**Rezoning Application:** PD 24-0141

**Development Services Department**

The applicant seeks to develop an approximately 7.19-acre property located on the east side of N. Saint Cloud Ave. and north of Washington Boulevard. The request is for a rezoning from Agricultural, Single-Family-1 (AS-1) to Planned Development (PD) to allow for the development of 26 single-family homes.

#### AGENCY REVIEW COMMENT SHEET

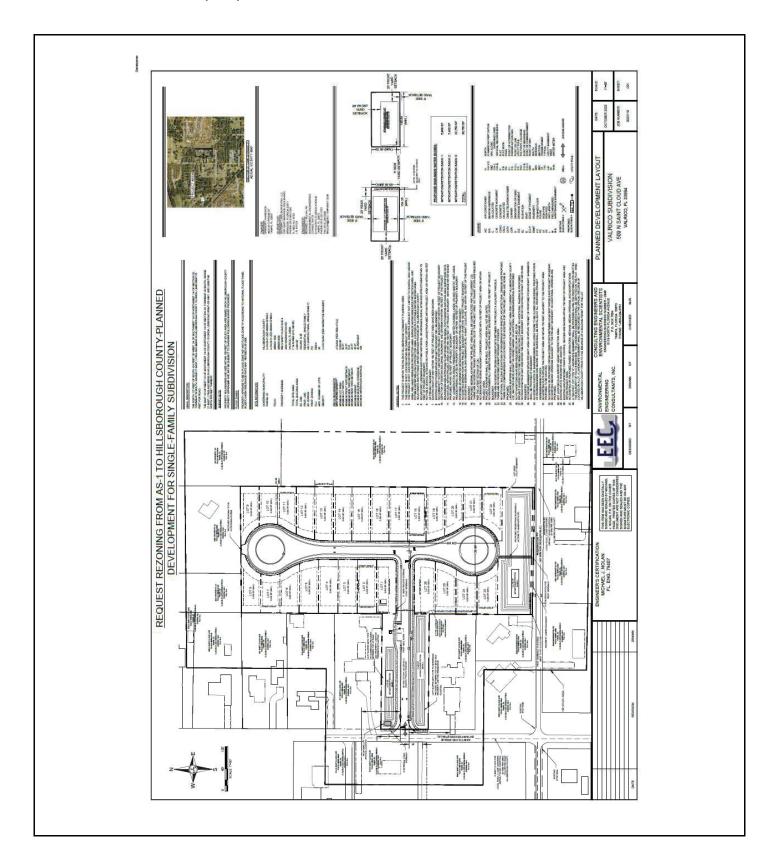
Prior to site plan certification, the applicant shall complete the following:

- Revise "50.40 ft." lot width to "50 ft." per RSC-9 zoning district standards.
- o Remove the min. lot length. RSC-9 standards will determine lot length.
- o Remove "Valrico Community Planning Area" under notes.
- o Remove the square box located on Lot 1.
- Revise the Site Plan to include sidewalks that continue to the property line to the north, as shown in image in the Transportation Agency Review Comment Sheet.
- Revise the Site plan to include sidewalk connections at the internal roadway intersection as shown in image in the Transportation Agency Review Comment Sheet.
- o Remove note #19. Project roadways are to be private roadways.
